RE: Docket FHWA-2020-0001, NPA for MUTCD

I submit the following comments in response to the Notice of Proposed Amendments (NPA) to the Manual on Uniform Traffic Control Devices (MUTCD).

Appendix A: Warning Sign Advance Placement Distances

FIGURE 1: Symbol Sign Legibility Distance

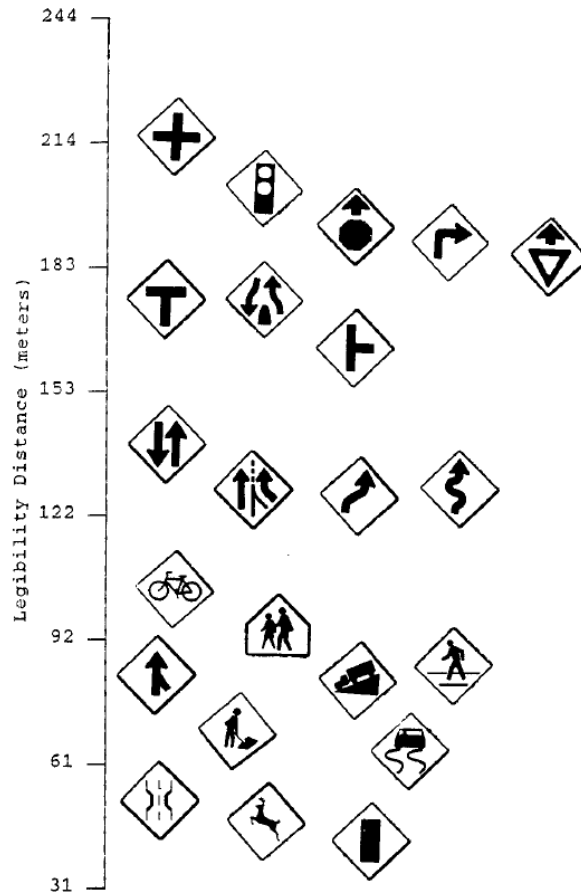
- ♦ A consistent value should be used for the sign legibility distance, at least within a given condition (A or B). NPA Table 2C-3 uses a legibility distance of 0 feet for the stop condition whereas the 2009 MUTCD uses a value of 180 feet. There is no justification for assuming that someone stopping will not see a sign until they are next to it nor should the legibility distance be based on a word message sign as the NPA has removed the option to use word messages when a symbol version of the sign is available. Research on symbol sign legibility has shown that the Signal/Stop/Yield Ahead signs have a legibility that is equal to or greater than that of a Turn/Curve sign (see Figure 1 in Appendix A of this comment). These signs all have a legibility distance greater than about 500 feet (150 meters). Therefore, 250 feet would be a minimum value to use for the legibility distance for the stop condition. I recommend FHWA use 250 feet for the sign legibility distance for the stop condition and consider a longer legibility distance for all symbol signs in a future rulemaking effort.

Changed the legibility distance for the stop condition from 0 ft used in the NPA to 250 ft (traffic control ahead signs are symbol signs with greater legibility)
